Response to Reviewer 2

Title: *Pressure Based Lift Estimation and its Application to Feedforward Load Control employing Trailing Edge Flaps*

Figure 1 Comparison between uncorrected balance measurements (dashed lines) and blockage corrected results (solid lines).

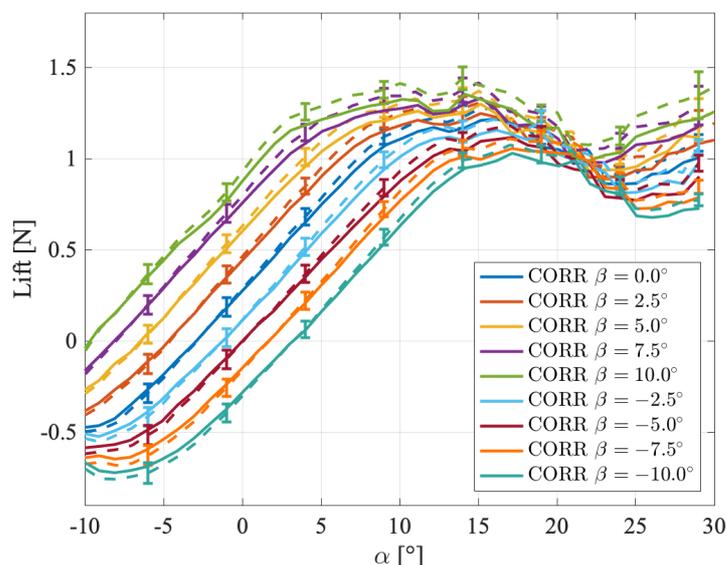
L5 Is this angle used in all comparisons? What about wind tunnel corrections for blockage, flow curvature etc?

We agree that a correction for solid body and wake blockage as well as stream line curvature is generally possible for this setup. However, the aim of the current paper is to compare different lift estimation methods between each other, which are partially calibrated on the underlying steady polars. Therefore, the fundamental outcome of the study is not changed as the correction would be propagated into the lift estimation methods. Nonetheless, if the interested reader is aiming for a CFD comparison all necessary parameters for blockage correction (chord, airfoil type, thickness, span, tunnel dimensions) are given in the paper.

Nonetheless, your point is taken, and the correction was calculated according to Barlow (Low Speed Wind Tunnel Testing 3rd ed, 1999). The result shown in the following figure, where the solid lines correspond to the corrected results. It can be seen that the difference in the linear region and for small flap angles is small, increasing towards larger angles of attack. However, as all following plots in the paper are grounded on the uncorrected values, this plot is not incorporated into the new manuscript in order not to confuse the reader.

Figure 2 Comparison of measured c_p distributions to XFOIL calculations. Exemplary $\alpha=5^\circ$ for three flap angles ($-5^\circ, 0^\circ, 5^\circ$) are shown.

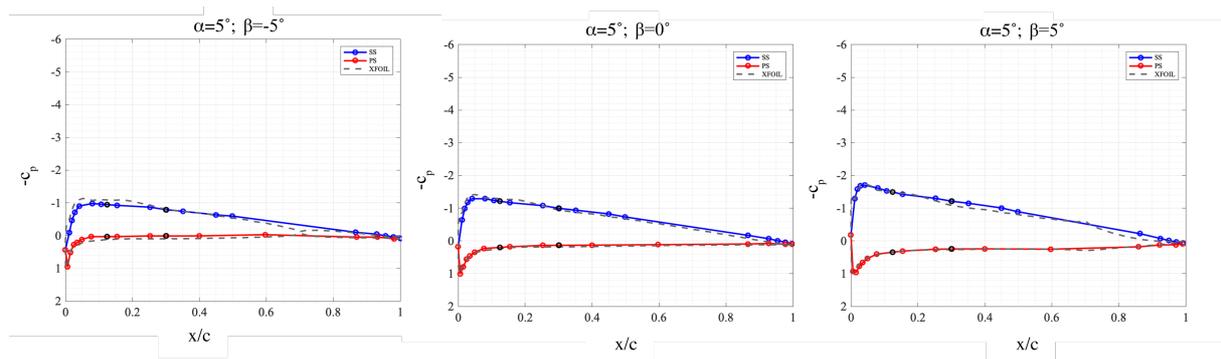
L19 This is the first time pressure taps are mentioned in the text. More detail is needed (when mentioned again afterwards): positions, size. Moreover, usually pressure taps are not located in the same spanwise position in order to avoid disturbances)

- 1) The coordinates of the pressure taps were added in a table in the appendix. Also the diameter of the holes is added to the manuscript.
- 2) Spanwise Positions: It is agreed that a varying spanwise position, which was not conducted due to manufacturing reasons, would have been beneficial for the results. However, a comparison of the c_p distribution to xfoil calculations yields satisfying results. This is expected due to the fairly large spacing between the pressure taps.

Figure 3 Lift comparison between balance measurements (dashed lines) and full pressure port integration (solid lines). Additionally XFOIL result for beta = 0° is shown.

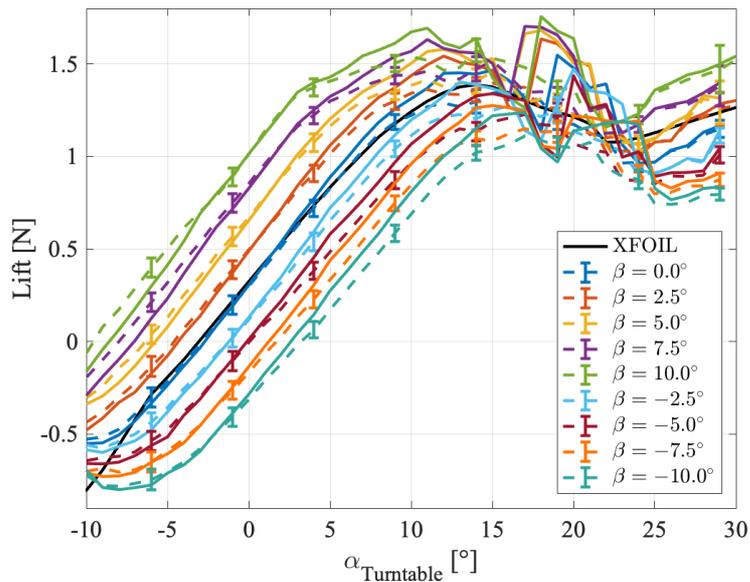
L2 It is very important when presenting these plots to verify how accurate the measured polars are compared to previous tests/CFD/even xFoil, especially considering the added disturbances of the setup. Moreover, the geometric angles of the turntable should not be used without including tunnel corrections. Is this the case? A steady state comparison of force balance and pressure taps should also be presented at some point, since the two methods are compared afterwards.

We agree to your comment. As this paper concentrates on lift estimation (and comparison) Figure 5 (polars of lift, drag and moment) of the original manuscript is exchanged for a figure presenting lift only. Herein, the comparison between balance measurements and lift calculations based on the integration of all pressure ports are shown. Furthermore, a comparison to XFOIL is shown for a flap angle of $\beta = 0^\circ$. Additional XFOIL polars for different flap angles are not added to keep the plot readable. The accompanying description of Figure 5 is changed in the manuscript.

Figure 4 Lift hysteresis plots; the calculation is based on the surface pressure port estimation method employed in the current paper (Velte et al 2012).

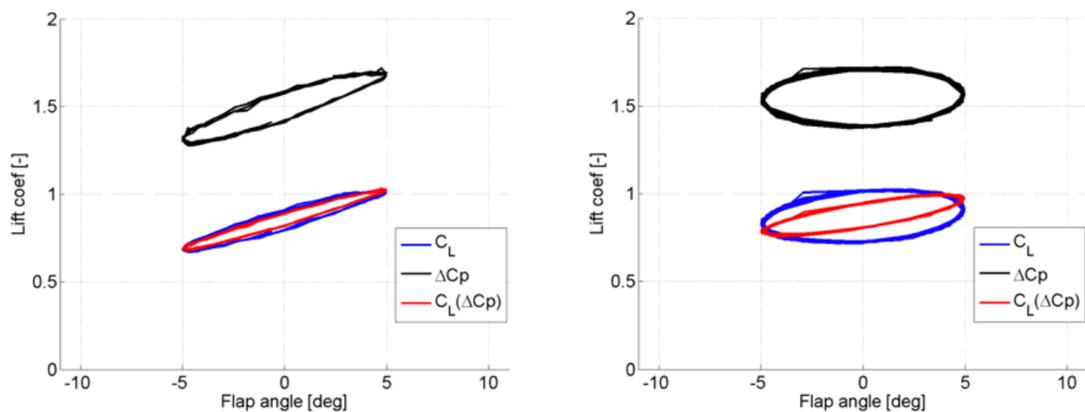
L12 Is the linear approximation the one used in the end? Then there are no unsteady effects.

This equation might be misleading. Actually a_{eff} contains the unsteady effects (in particular wake memory, no added mass). Please refer to

where their Figure 7 (which is shown here below) shows alpha - lift hysteresis calculated with the same methodology. Thereby it is confirmed, that unsteady effects are included. Otherwise there would be just a flat line.

Figure 5 This is Figure 15 from the original manuscript. It is copied here to show that the angle of attack excursion remain in the linear region.

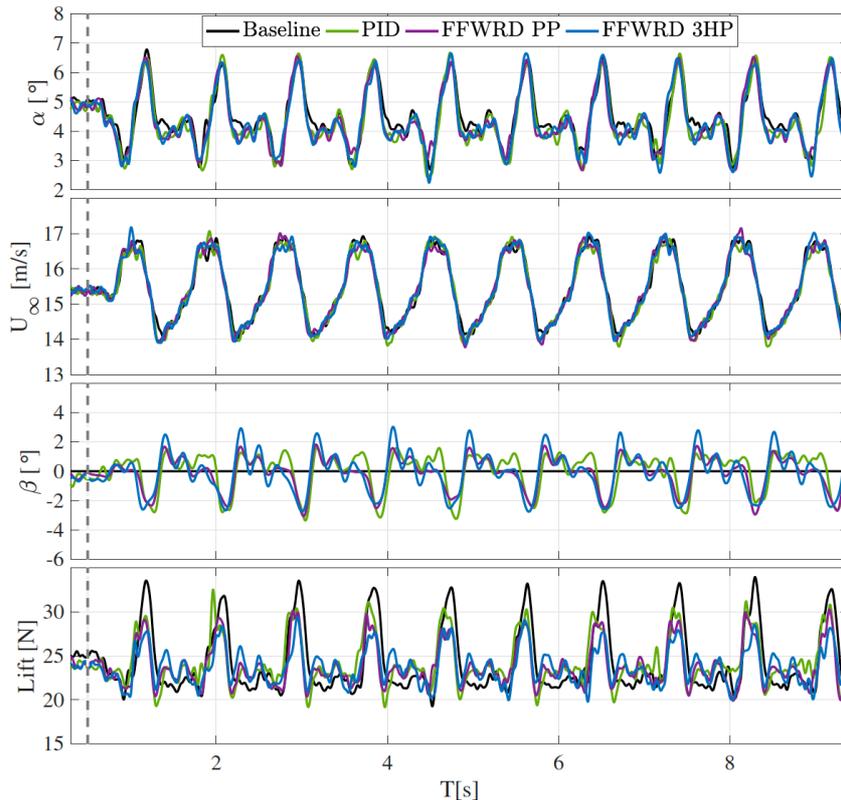
L 18 Why only linear function of flap angle, and not employ the look-up data? The delta(Cl) per flap angle is not constant for every angle of attack.

We generally agree to your comment, this would have improved the results. However, the effect is considered small as the presented results for the dynamic inflow lead to angle of attack excursion of $\pm 2^\circ$ (remaining in the linear region of the lift curve) around the mean AOA of 5° (please compare to Figure 15 which is copied after this paragraph).

For future application this will be taken into account. Your point is included in the summary section to highlight the improvement potential.
